Exhibit E

SITE PLAN
GURUDWARA NANAKSAR
 3060 S. CHERRY AVE.
 FRESNO, CA 93706

DATE: 03/29/2024
 JOB: 17-41
 DWG. BY: HS
 CHK. BY: MG
A1.0.0
 SHEET
 7 OF 44

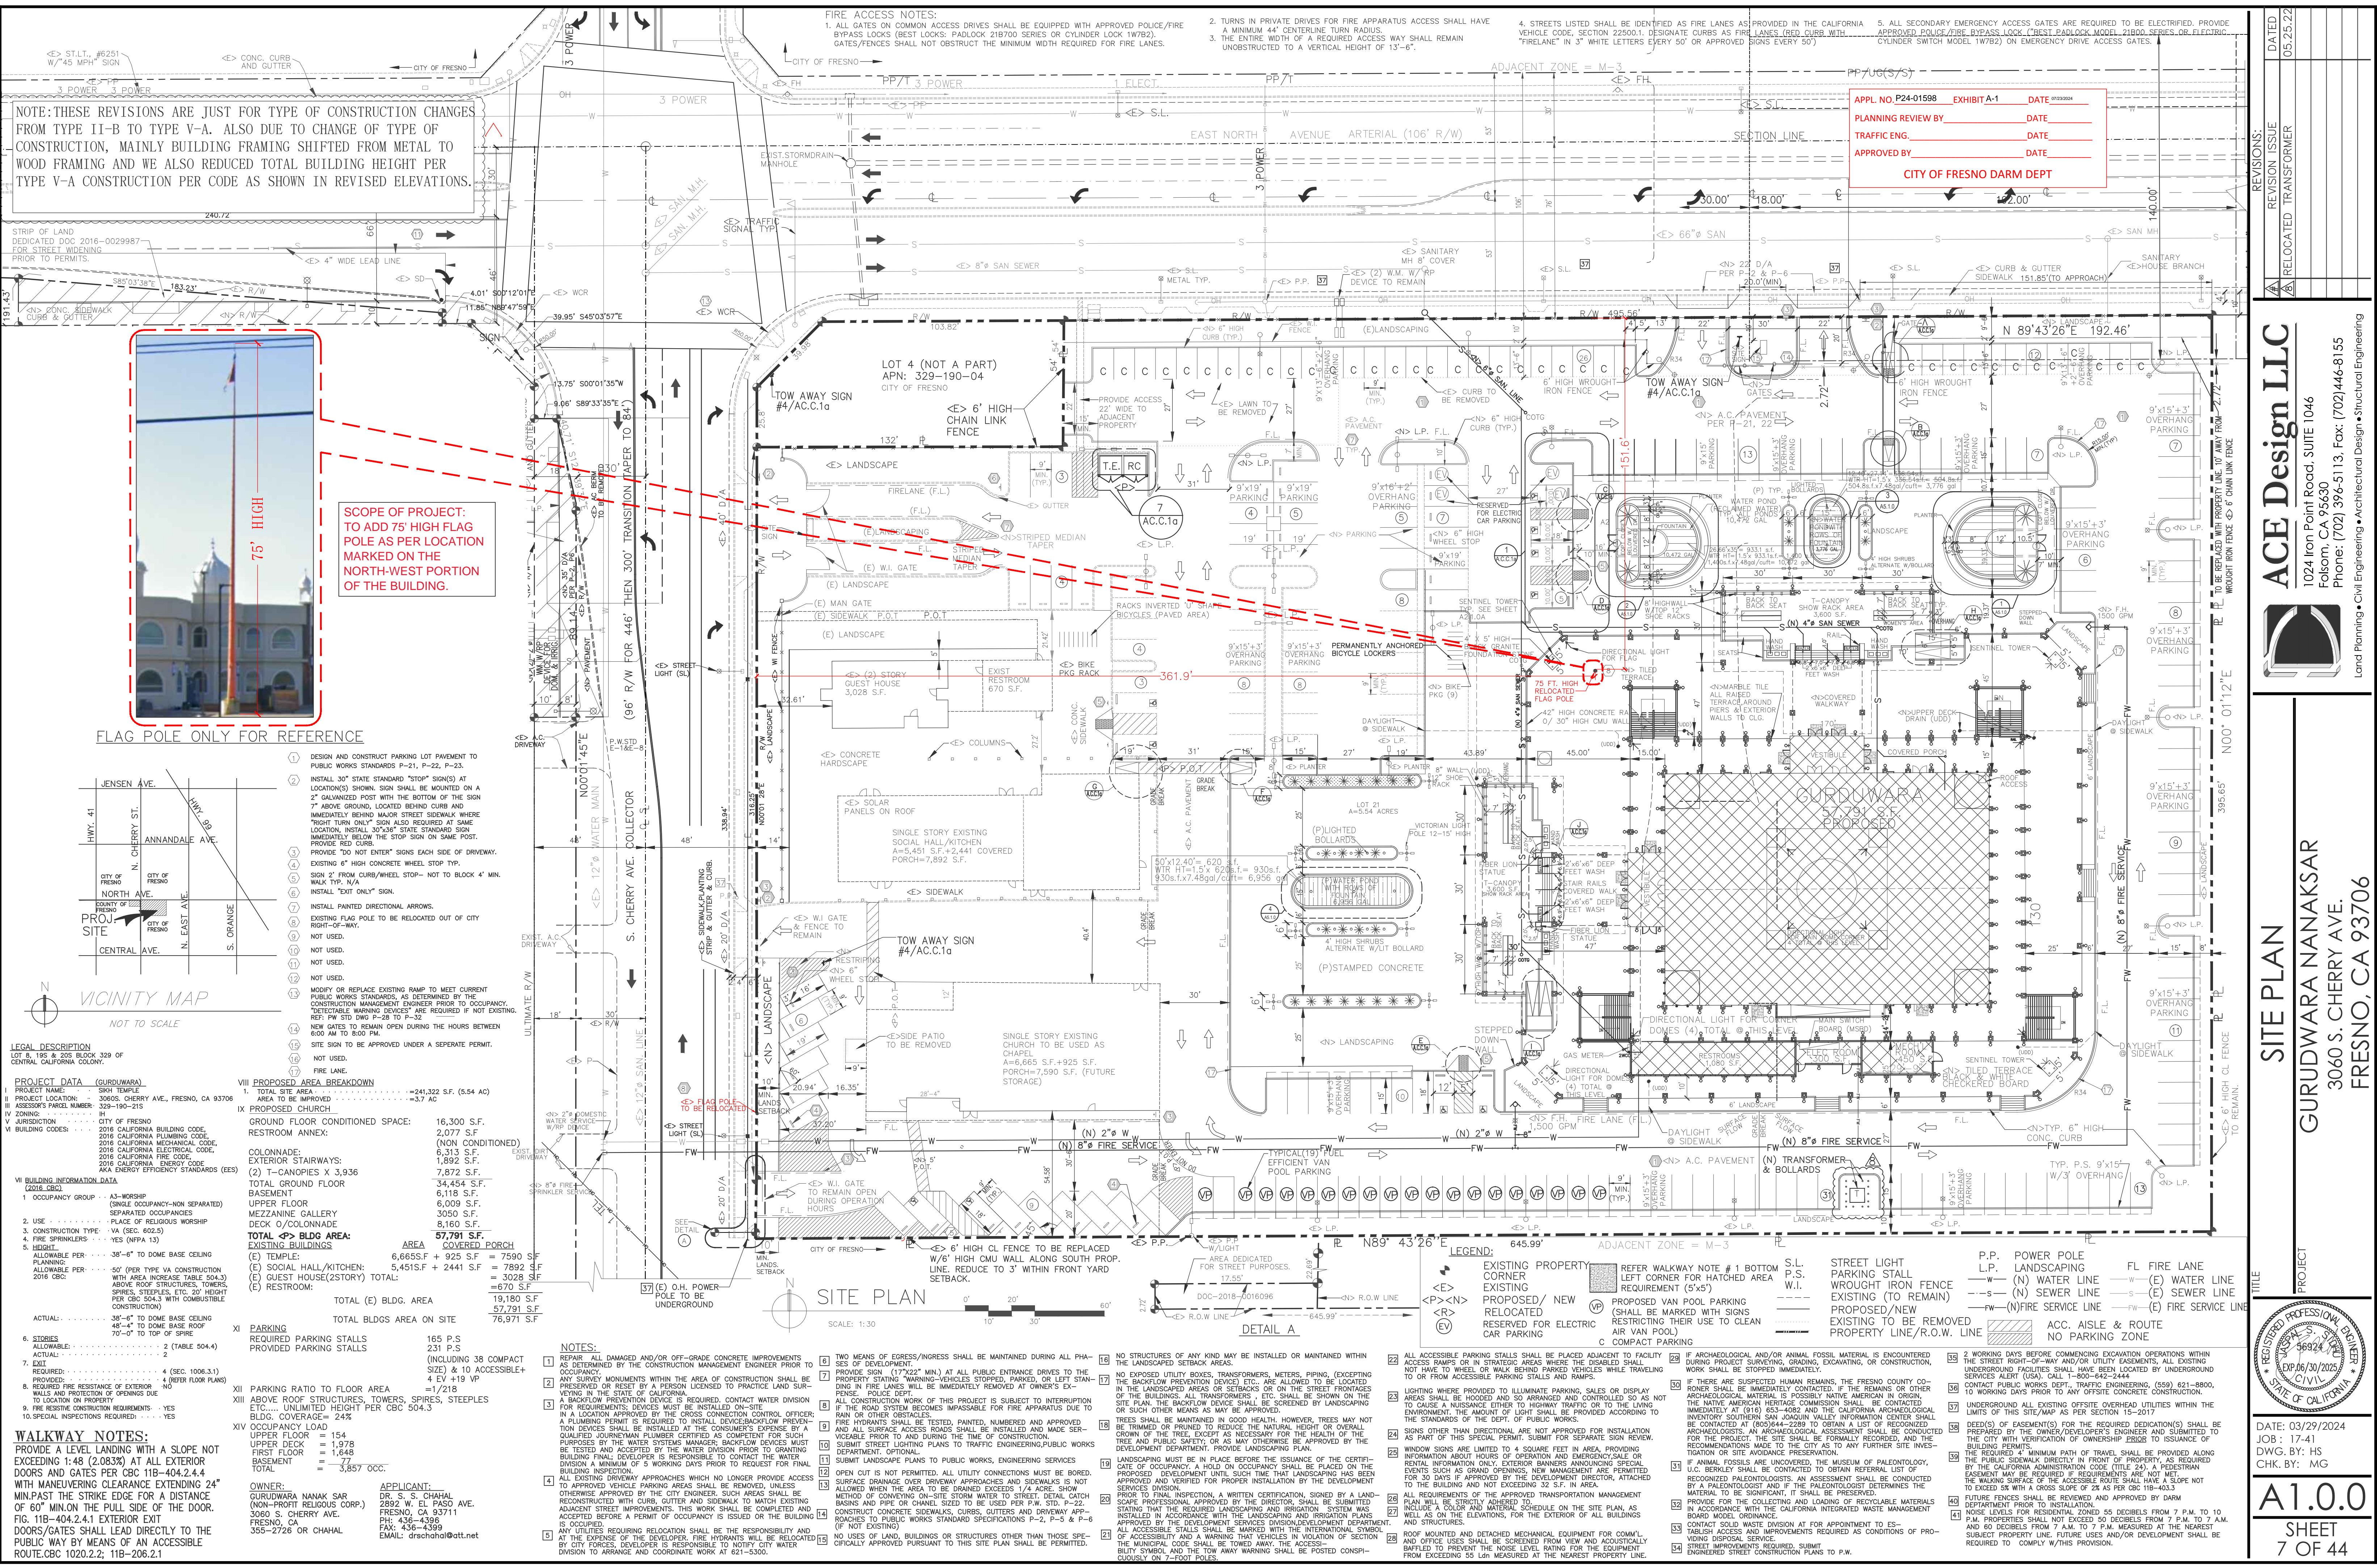
NOTE: THESE REVISIONS ARE JUST FOR TYPE OF CONSTRUCTION CHANGES FROM TYPE II-B TO TYPE V-A. ALSO DUE TO CHANGE OF TYPE OF CONSTRUCTION, MAINLY BUILDING FRAMING SHIFTED FROM METAL TO WOOD FRAMING AND WE ALSO REDUCED TOTAL BUILDING HEIGHT PER TYPE V-A CONSTRUCTION PER CODE AS SHOWN IN REVISED ELEVATIONS.

SCOPE OF PROJECT: TO ADD 75' HIGH FLAG POLE AS PER LOCATION MARKED ON THE NORTH-WEST PORTION OF THE BUILDING.
